Main Drainage Channels for Ngau
Tam Mei, Yuen Long and Kam Tin:
Environmental Schedule

23 May 1996

Response to Comments
Main Drainage Channels for Ngau Tam Mei, Yuen Long and Kam Tin, EIA Study - Draft Final Environmental Schedule

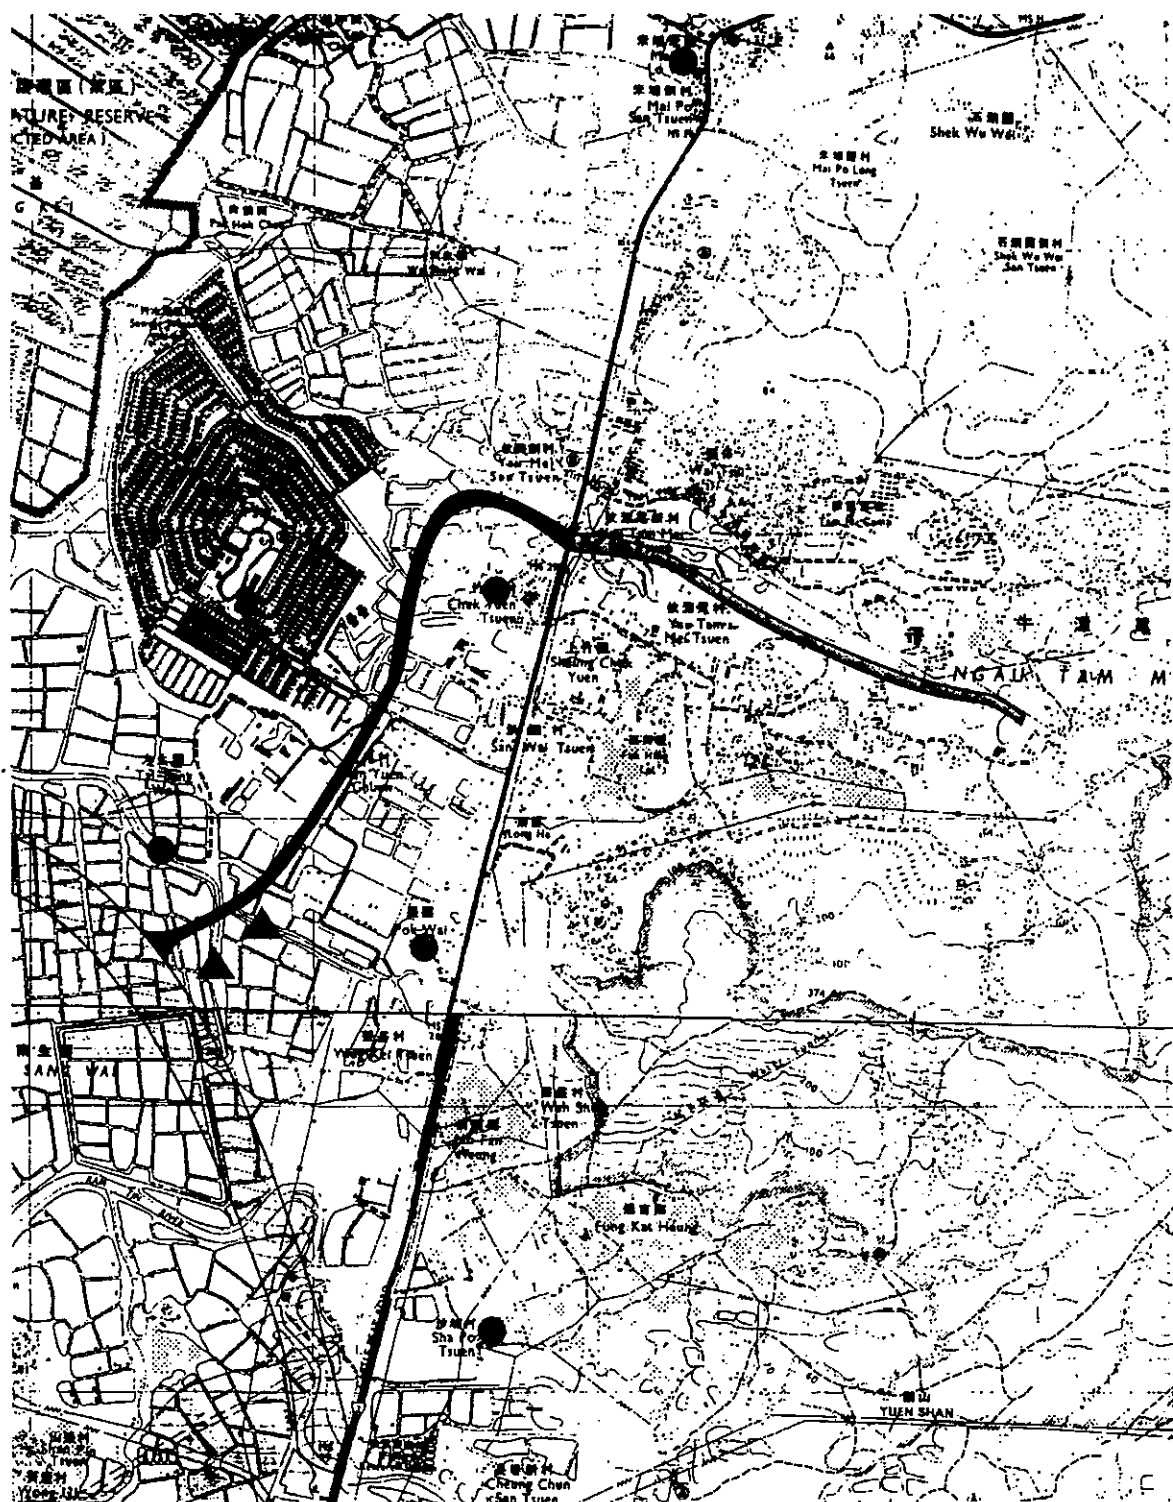
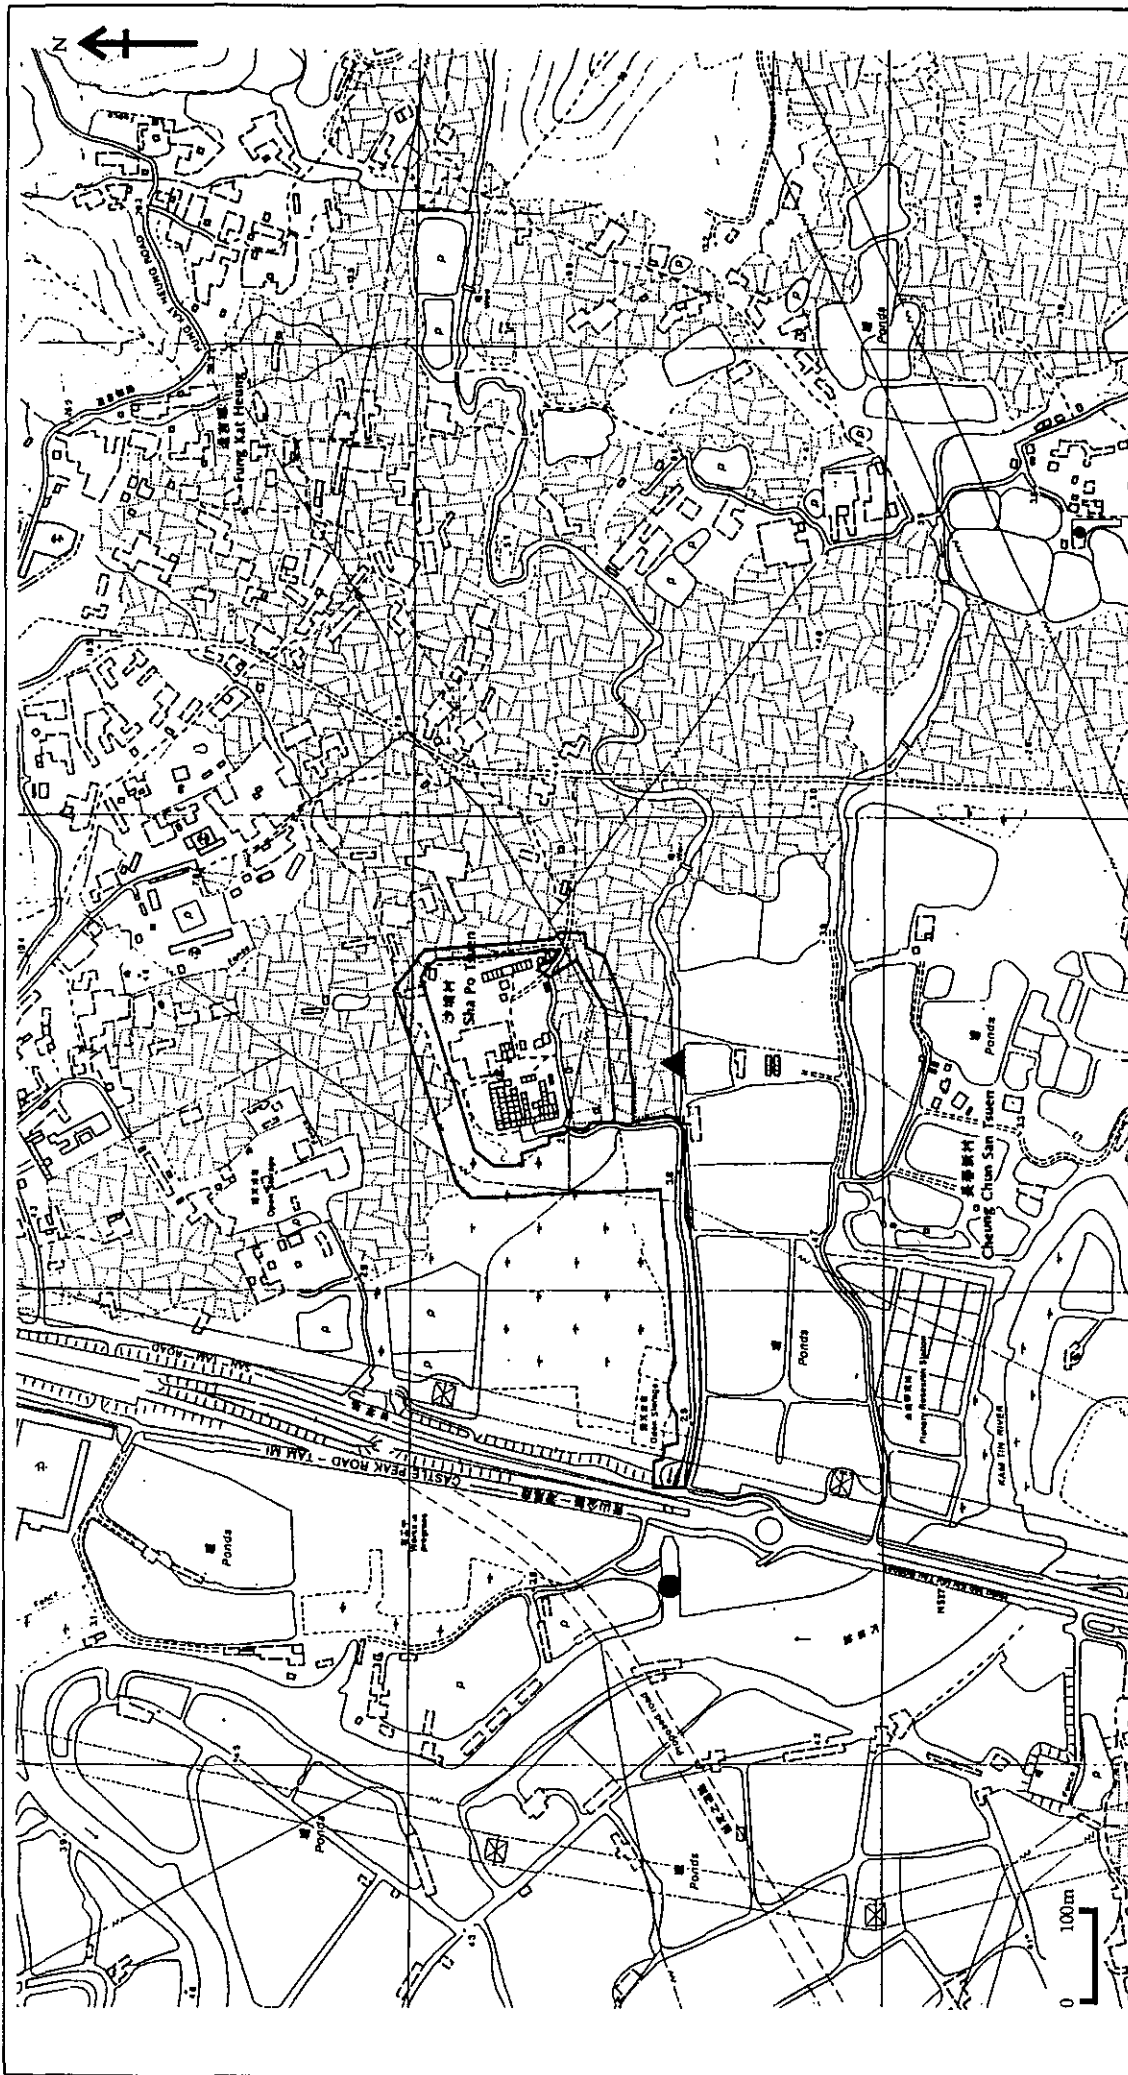
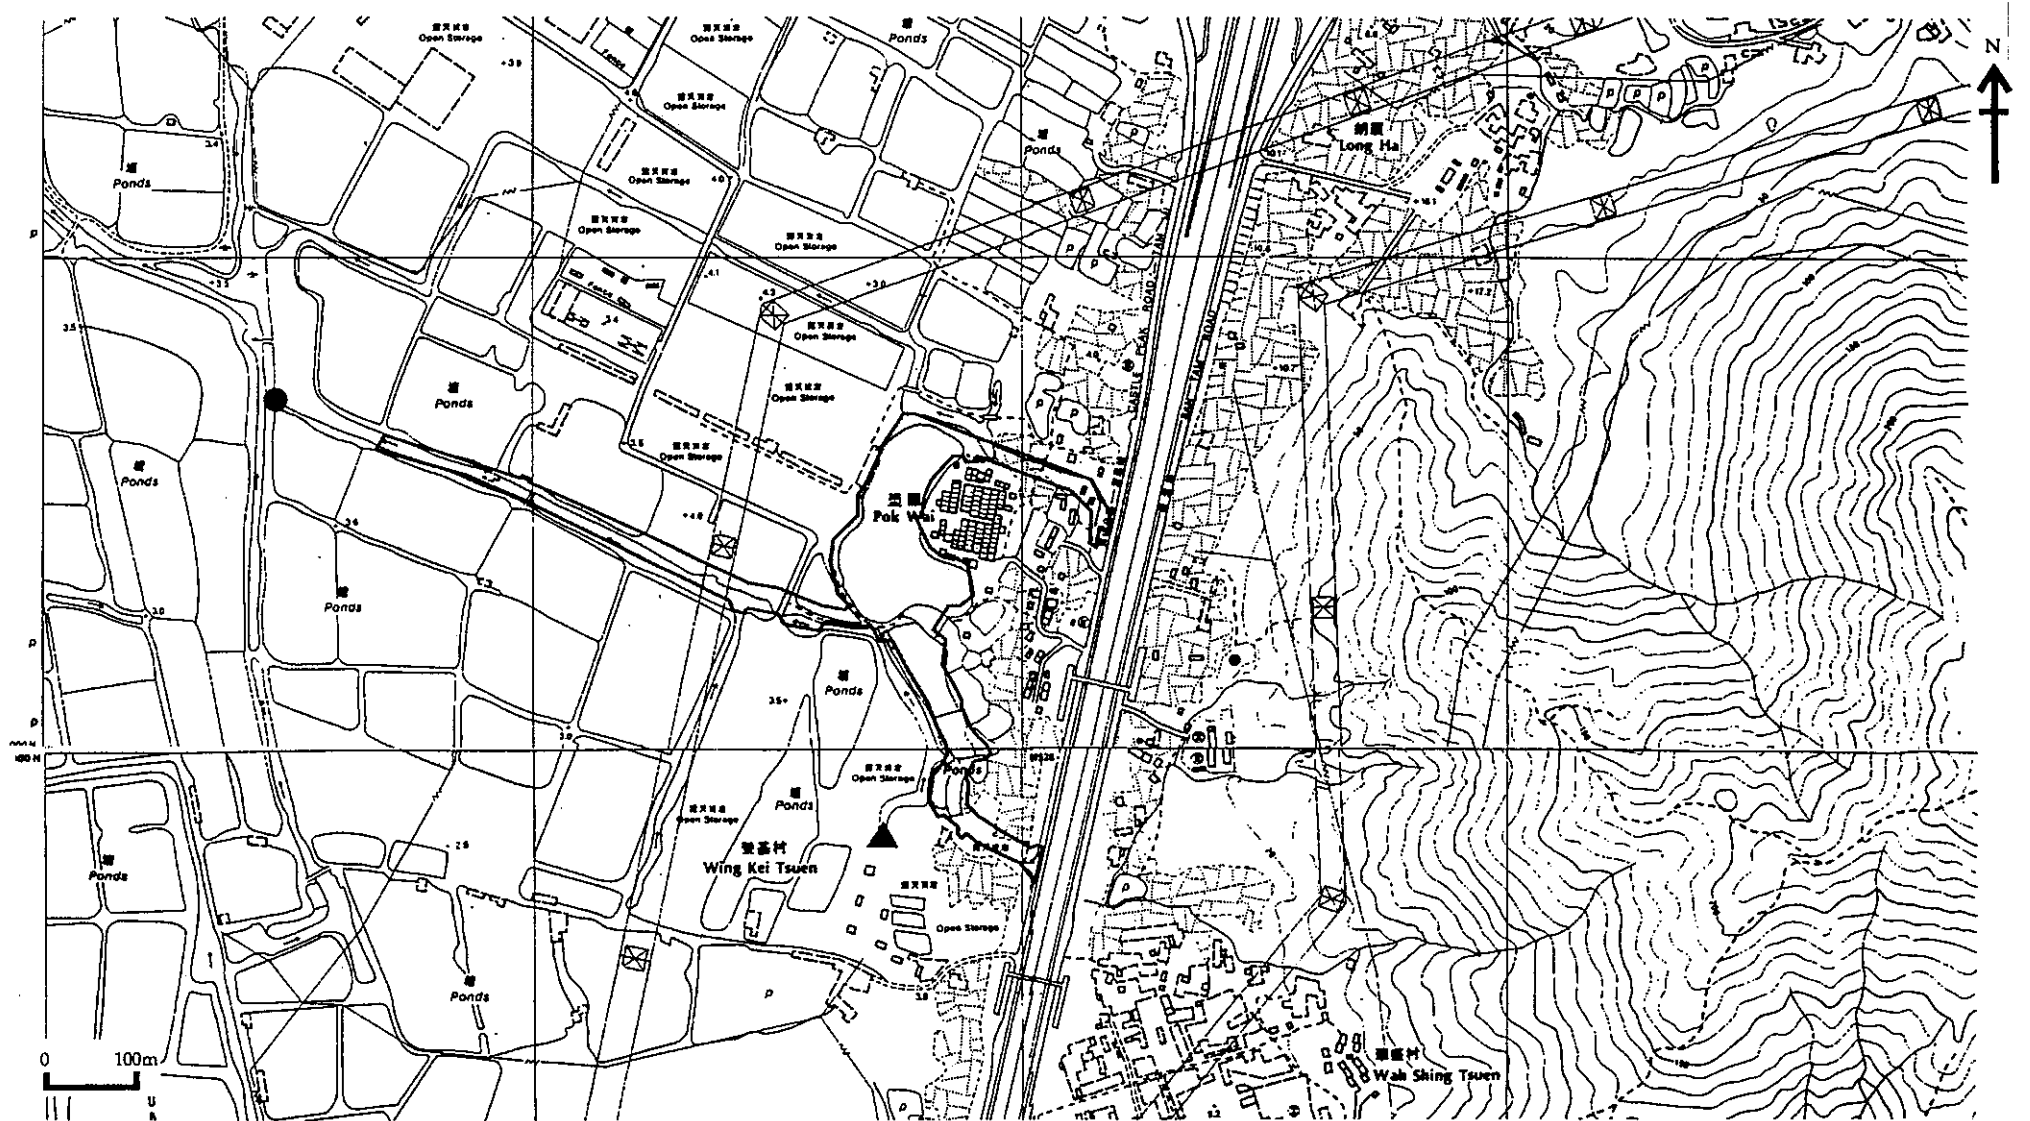
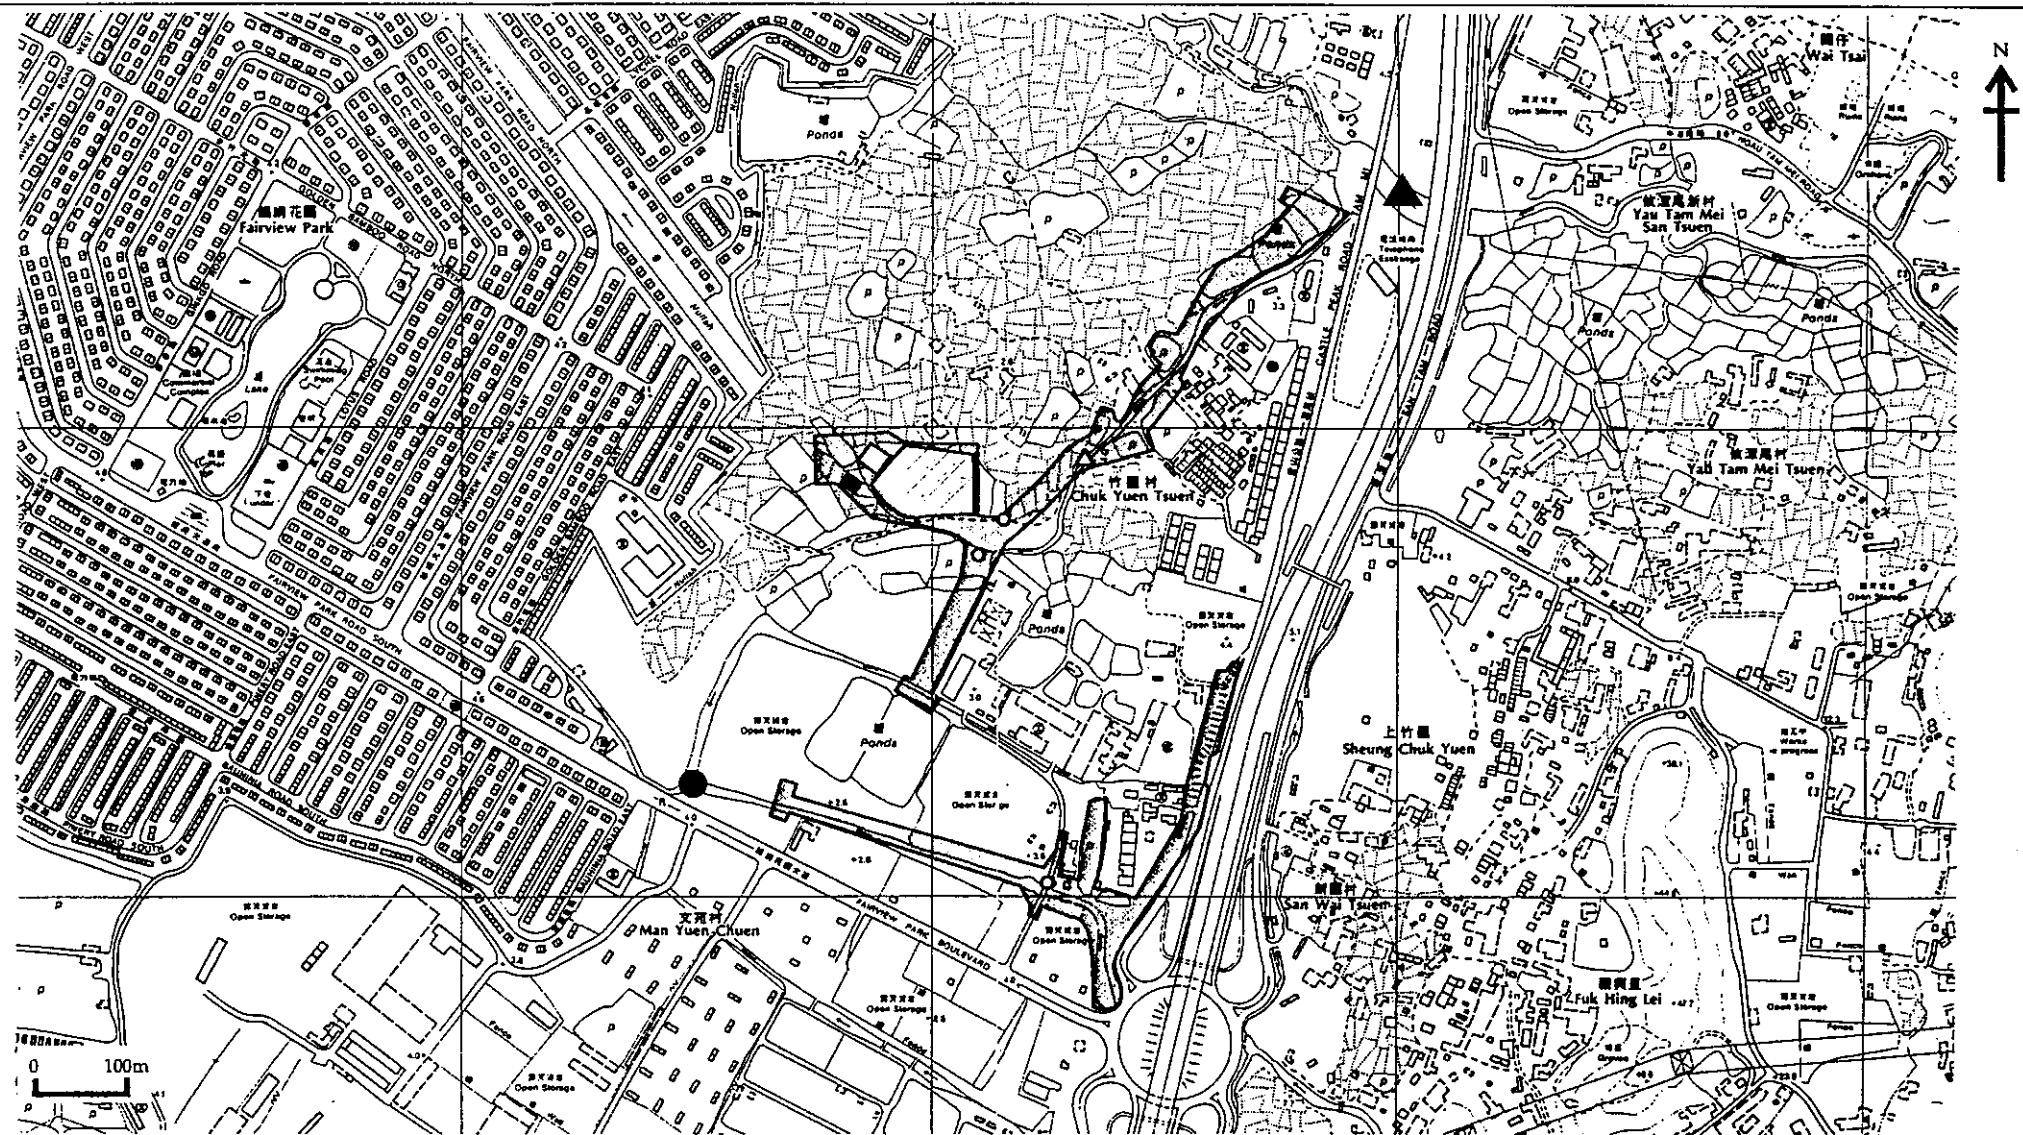
16.			ii) Figures 5.1a to 5.12k are not legible and should be further improved so that all the locations, grid co-ordination, existing rivers or streams and the construction areas can be well and clearly identified. Please make sure that all the monitoring and control stations are accessible and shown correctly in the drawings.	The clarify of all ES figures has been improved accordingly. See also response to comment 15 re: grid coordinates.
